Revised Flood Risk Assessment Addendum

Job Name: Lotmead Farm, Swindon

Subject: Revised Addendum to Flood Risk Assessment

Job Name: Lotmead Villages, Swindon
Job No: 27970/4008
Note No: TN201901
Date: 14/08/19
Prepared By: S Bari
Subject: Response to EA model review ref 2018s0387

Figure 1) Downstream boundary location

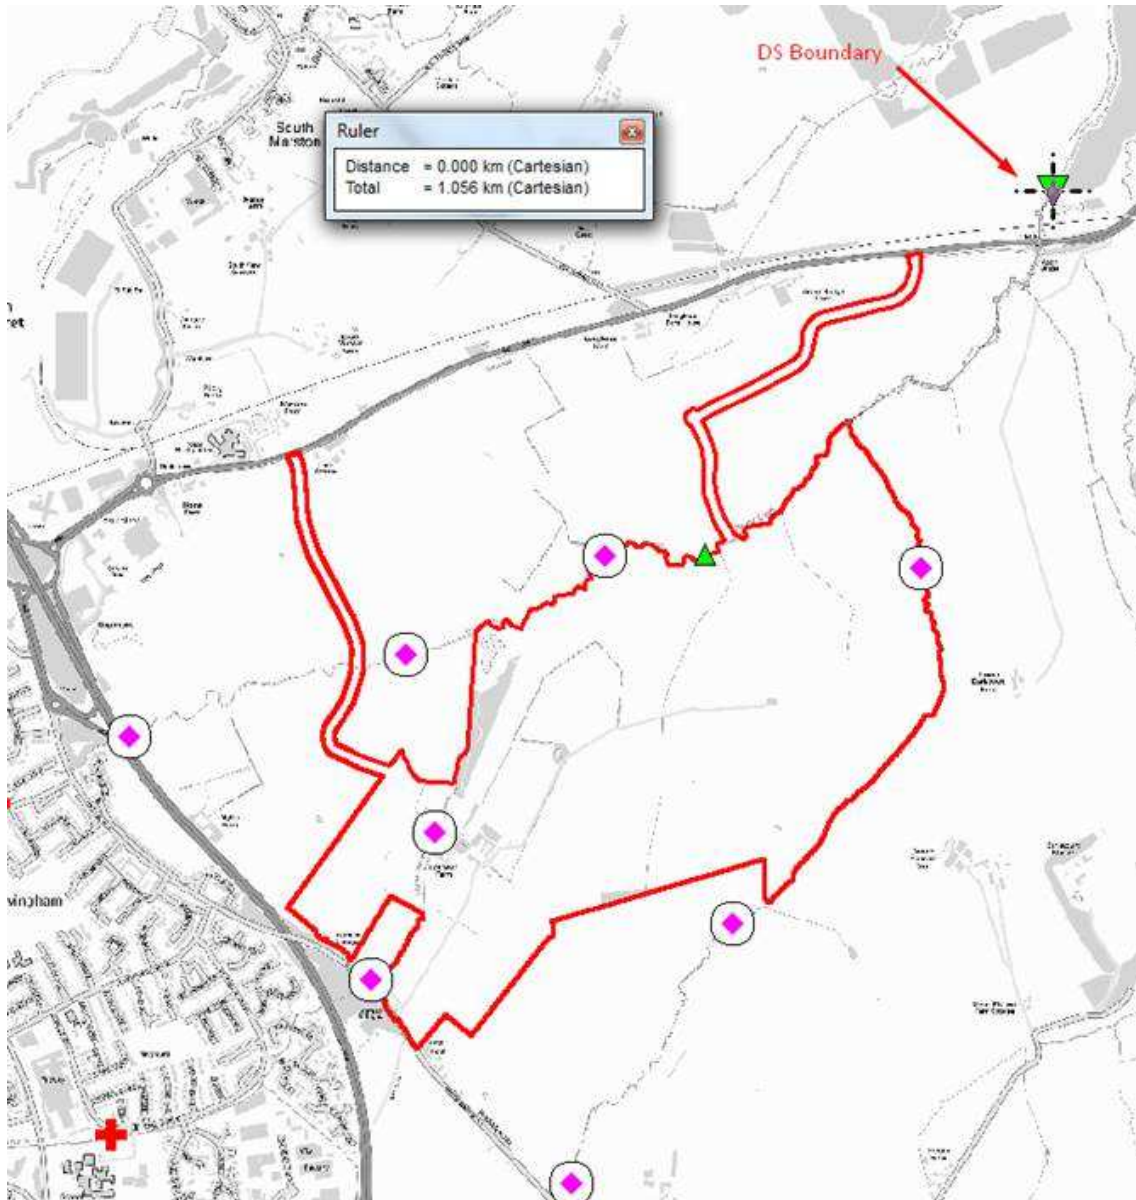
'Coincidentally whilst checking the HQ was sufficient for the +70% CC flows it has been noted it has been applied incorrectly. Flow should be in the first column of the curve and stage in the second. See output from the 1d_bc check file. As such, the stage at the downstream node of the model is set at the bed level of cross section.'

- 2.2. The reviewer's comments are correct. This error was present in the original EA hydraulic modelling and unfortunately, was not identified during our update. Our modelling did not look to alter the downstream boundary conditions from the original calibrated EA model so we were not alerted to this discrepancy at the time.

- 2.3. As the downstream boundary condition in the model is set to the bed level of the channel rather than using the HQ rating curve, this would lead to a local drawdown in the modelled flood level at the downstream of the model.

- 2.4. However, having reviewed the model, the 1d downstream boundary condition has only a negligible impact on the modelled water levels at the site for the following reasons.

- The downstream boundary is located over 1 km downstream of the site – it is unlikely that any drawdown effect would extend this far upstream.
 - The boundary is located behind two significant flow control structures across the floodplain – the A420 road and the railway line. These would act as a downstream control and prevent any artificial drawdown of flood levels at the downstream boundary extending further upstream to the site.

- 2.5. **Figure 1.** below indicates that location of the site and the downstream boundary and shows the downstream boundary is over 1 km away from the site.

Figure 5) EA model inflow boundaries

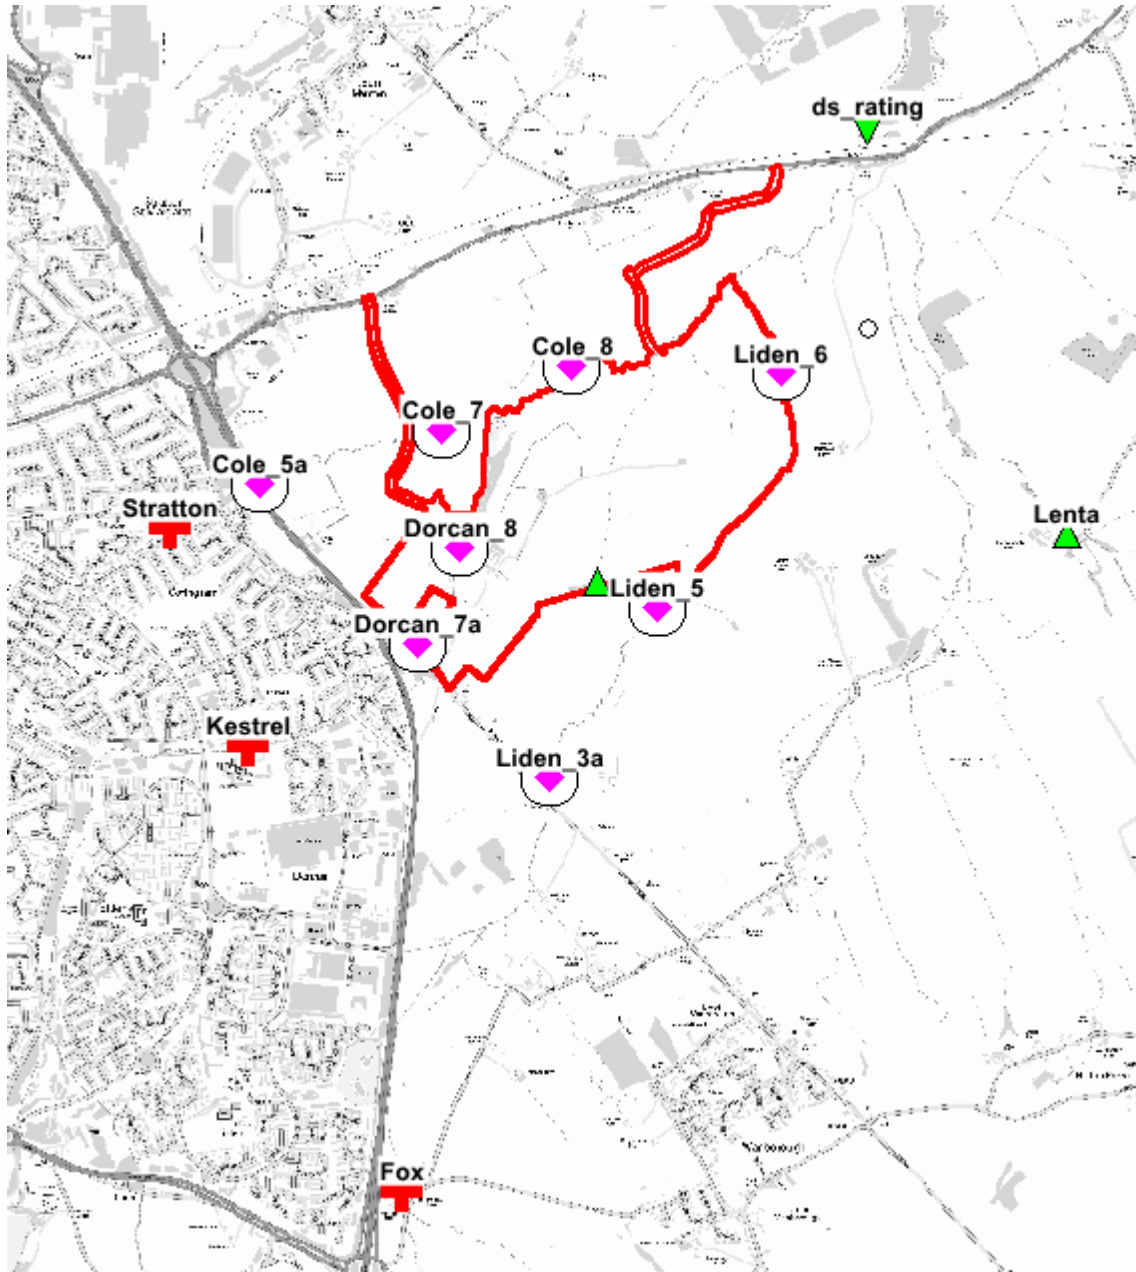
'It should be noted that in the bc_dbase an inflow named "ditchA" is present for both the 100-year + 35% climate change and 100-year +70% climate change events bc_dbases but isn't in the inflow CSV's. Additionally, "Input_G_Lta" is noted in the inflows CSV but not in the 1D QT boundaries. Should these flows be applied?'

- 3.4. Input_G_Lta was included in the flow data .csv file from the EA model however it was not used in the their final model. **Figure 5.** shows the inflow labels from the EA model (1d_bc_swin_077), which does not include Input_G_Lta. Therefore the omission of this inflow is consistent with the existing EA model.

3.5. As such the comments on the inflow boundaries do not need to be considered further.

Figure 6) Location of messages

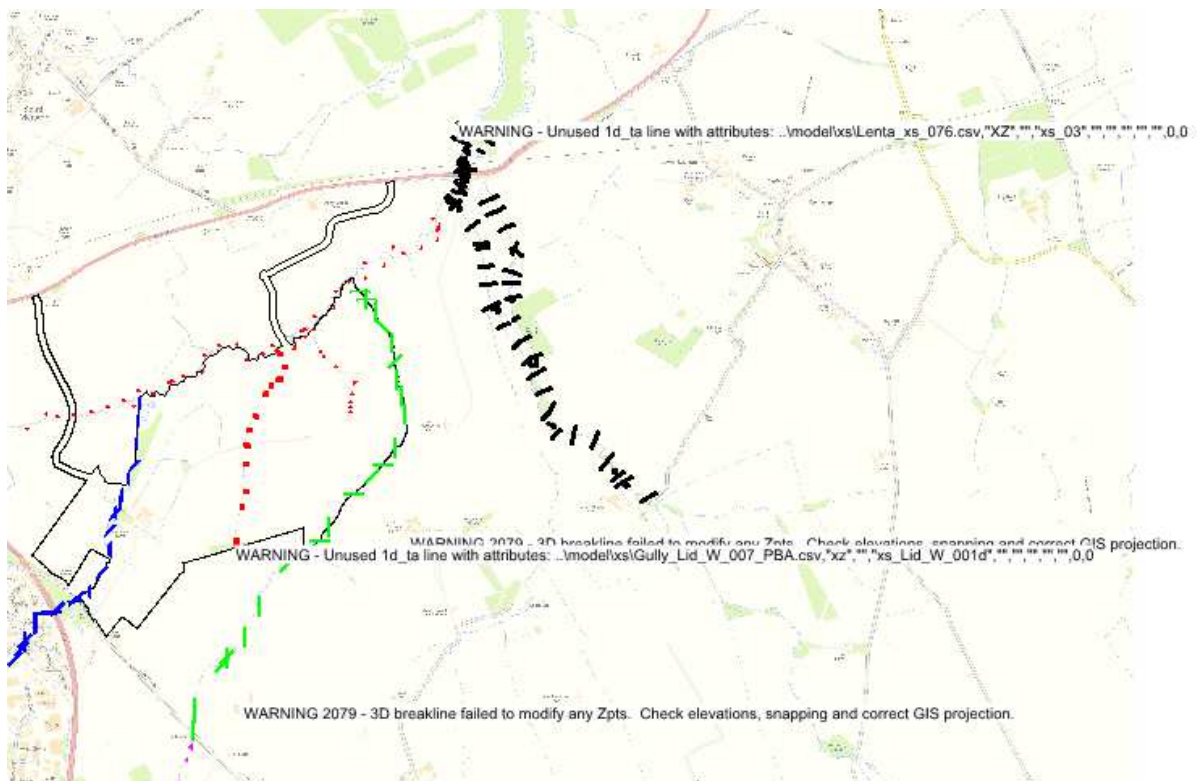
- *"WARNING - Unused 1d_ta line with attributes: ..\model\xls\Lenta_xs_076.csv"*
- *"WARNING - Unused 1d_ta line with attributes: ..\model\xls\Gully_Lid_W_007_PBA.csv"*
- *"WARNING 2079 - 3D breakline failed to modify any Zpts. Check elevations"*
- *"WARNING 2079 - 3D breakline failed to modify any Zpts. Check elevations"*

5.3. PBA has investigated the locations of these messages. **Figure 6.** shows the locations of these messages.

Figure 9) EA 1000 year dVol and Cumulative Mass Balance Error (%)

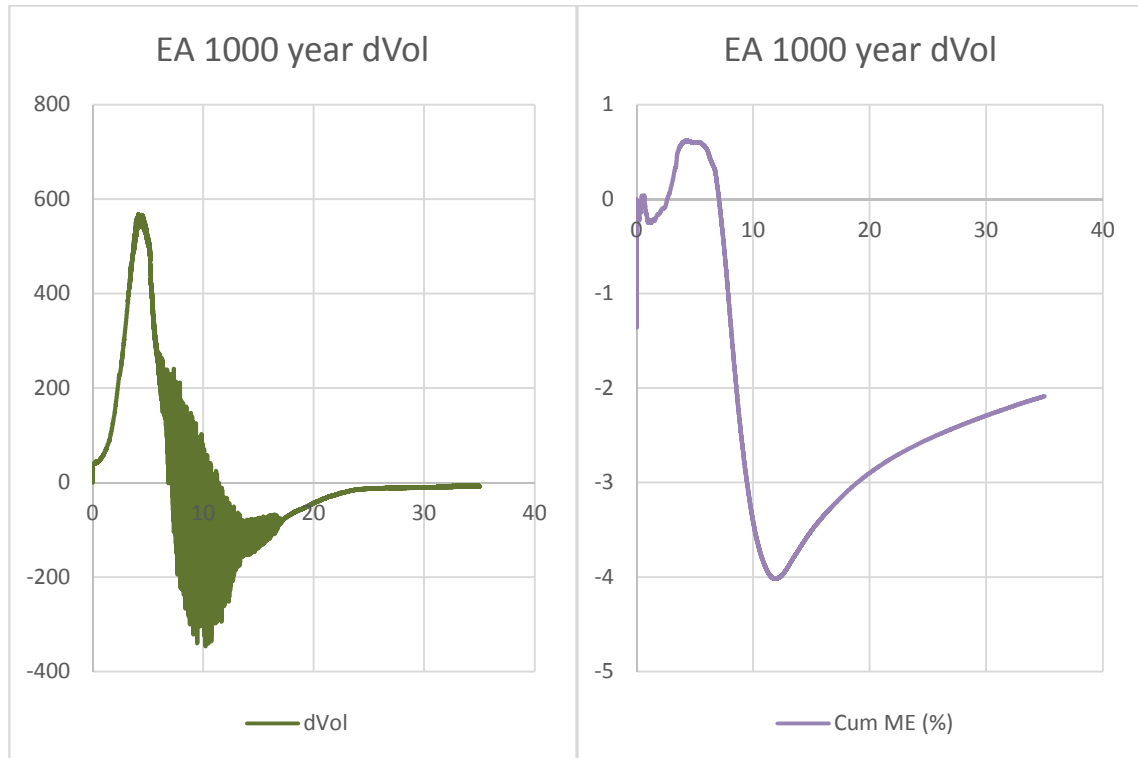
'dVol for both runs has a sensible profile but notable oscillations. The reviewer has looked at the results in the 1D domain in the vicinity of the site and from a random inspection there does not appear to be any significant oscillations in either flow or stage within the vicinity of the proposed development. Potentially, this is an issue with another part of the model. Without model results from the original model the reviewer cannot determine if this is something caused by the climate change inflows or the original model.'

6.2. This comment is not considered significant, the reviewer indicates that this is likely to be a legacy issue within the EA model and does not influence the model at the site. **Figure 9.** shows the EA dVol and cumulative ME for the 1000 year results, which indicates similar profiles and oscillations as PBA's models.

6.3. The oscillations in dVol and the cumulative Mass Balance Error (%) in the PBA modelling have been inherited from the EA model, consequently, it is considered that this comment does not need to be addressed further.
